SERVICE LETTER

HL-102
DL-76
EL-27
FL-18

ADDITION OF IDENTIFICATION DECAL ON AIRCRAFT EXTERIOR (COMPLIANCE TO FAR 45.11 [D])

Figure 1. Location of Exterior Helicopter Identification Decal

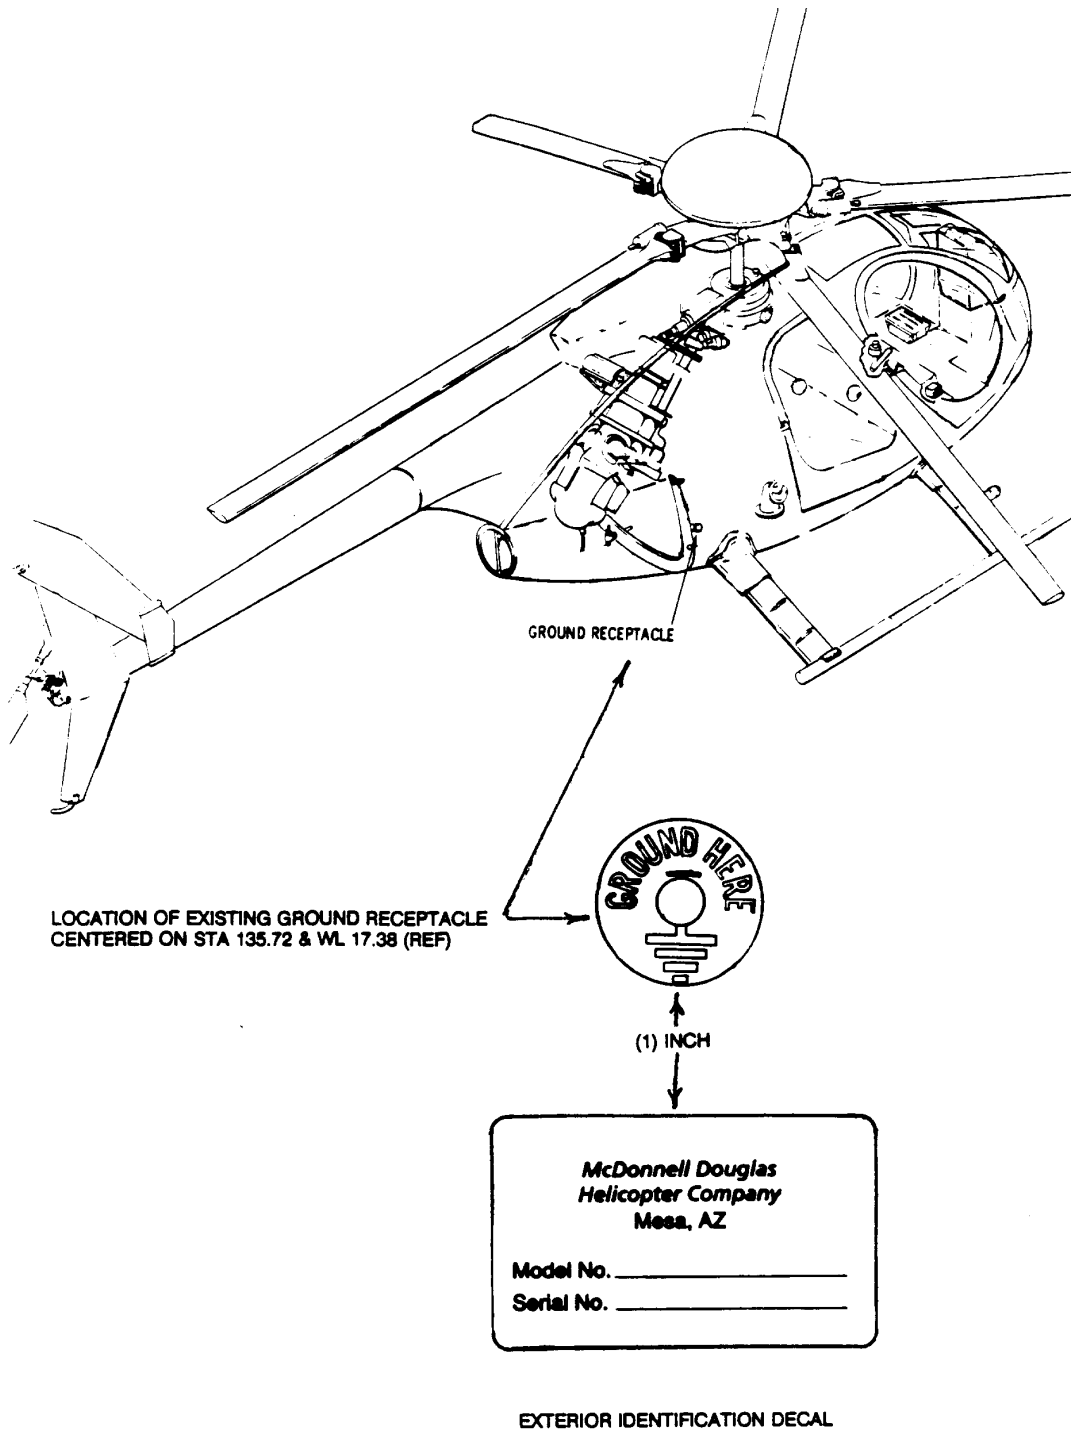
- a. Ensure surface is clean and dry prior to installation of decal.
- b. Install decal in location shown on Figure 1 attached.
- c. Apply a bead of sealant around the faying surfaces of the decal.
- d. Use the attached form when ordering exterior identification decals.
